ENGINEERING CHANGE PROPOSAL (ECP), PAGE 1 OF 4

13. TITLE OF CHANGE
SPANNER WRENCH MODIFICATION

16. CONFIGURATION ITEM NOMENCLATURE
Tool Kit, Gun Tube 9338574

19. DESCRIPTION OF CHANGE
RELEASE NEW SPANNER WRENCH 12988501 TO REPLACE SPANNER WRENCH 12310828, USED DURING MAINTENANCE OF THE 120 MM GUN TUBE.

SPANNER WRENCH

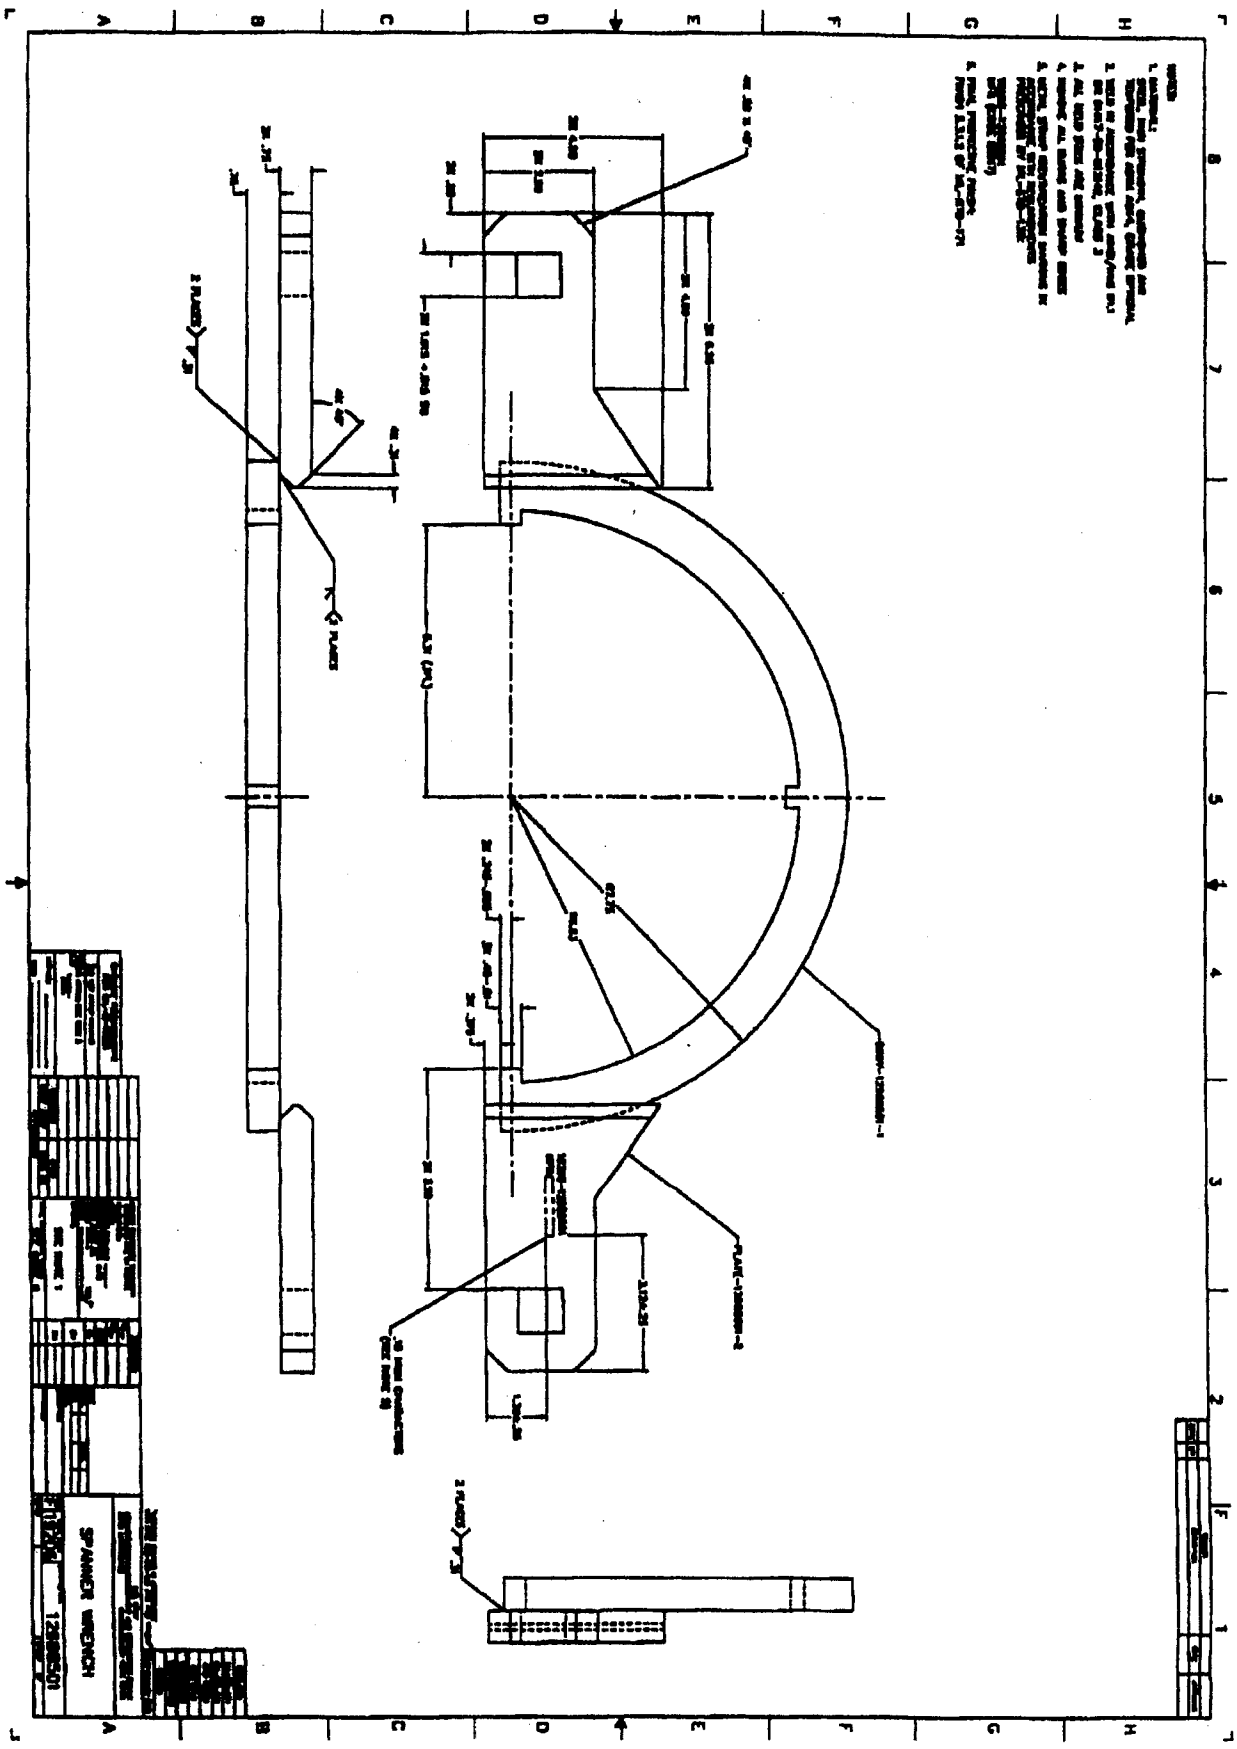
20. NEED FOR CHANGE
SPANNER WRENCH 12310828 WAS PREMATURELY FAILING. PROPOSED NEW SPANNER WRENCH 12988501 HAS THREE GRIPPING POINTS INSTEAD OF TWO AND USES .75 THICK PLATE IN LIEU OF .38 THICK MATERIAL.

SEE ATTACHED PROPOSED NEW DRAWING 12988501
